# Access Compliance Report

## Public Rights-of-Way

### (Curb Ramps)

Intersection ID: N/A	Main Street: BREVARD_ST	Cross Street: STONEWALL_ST	Location: N
ADA ID: 5B44B320911F	Ramp Type: BlendTrans1	Initial Pass/Fail: Fail	Overall Compliance: No
Severity Score: 12.5			
Codes/Mitigation Info/Possible Solution		Field Measurements/Component Compliance

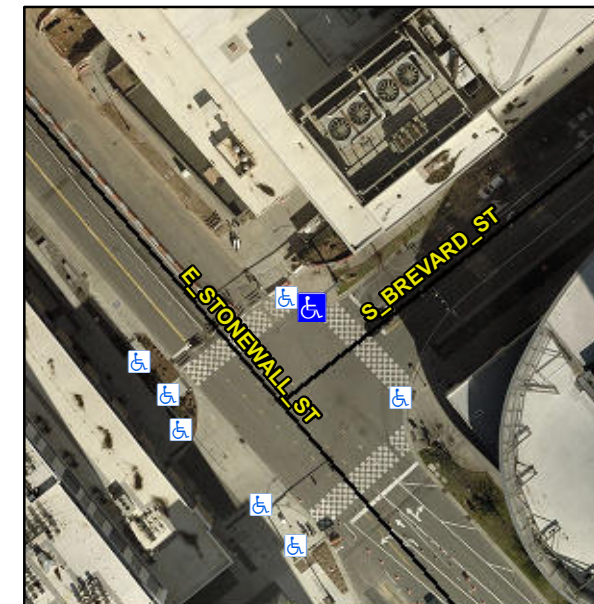
**Not Found, R304.5.3**

Compliance	Description	Data	Compliance	Description	Data
N/A	Ramp Length (in)	83.0	Yes	BlendTrans Slope (%)	2.0
Yes	Ramp Width (in)	67.0	No	BlendTrans XSlope (%)	5.1
N/A	Flare Type LT	N/A	N/A	Flare Type RT	N/A
N/A	Flare Slope LT (%)	N/A	N/A	Flare Slope RT (%)	N/A
N/A	Flare Traversable LT?	N/A	N/A	Flare Traversable RT?	N/A
N/A	Landing Length (in)	N/A	N/A	DWS Provided?	N/A
N/A	Landing Width (in)	N/A	N/A	DWS Contrast?	N/A
N/A	Landing Slope (%)	N/A	N/A	DWS Length (in)	N/A
N/A	Landing X Slope (%)	N/A	N/A	DWS Full Width?	N/A
N/A	Landing Curb? (Y/N)	N/A	N/A	DWS Offset (in)	N/A
N/A	Shared Landing?	N/A			
N/A	Gutter Ponding?	N/A	N/A	Gutter Slope (%)	N/A
N/A	Gutter Lip Ht (in)	N/A	N/A	Gutter X Slope (%)	N/A
N/A	Painted X Walk1?	Yes	N/A	Painted X Walk2?	N/A
	X Walk 1 Direction	To SE		X Walk 2 Direction	N/A
	X Walk 1 Width (in)	144.0		X Walk 2 Width (in)	N/A
	X Walk 1 Slope (%)	0.6		X Walk 2 Slope (%)	N/A
	X Walk 1 X Slope (%)	4.3		X Walk 2 X Slope (%)	N/A

N/A	Ramp inside XWalk1?	Yes	N/A	Ramp inside XWalk2?	N/A
	Road Slope (%)	4.3		Clear Space?	N/A
	Road X Slope (%)	0.6	N/A	Clear Space to XWalk (in)	N/A
N/A	Any Obstructions?	N/A	N/A	Storm Grate/Utility Hazard?	N/A
	Obstruction Type			Storm Grate/Utility Type	
		N/A			N/A
			Yes	Surface Condition? (G/P)	Good
			No	Curb Slope (%)	15.2

**Remove & Replace Curb Ramp With Two New Directional Ramps or Equivalent.**
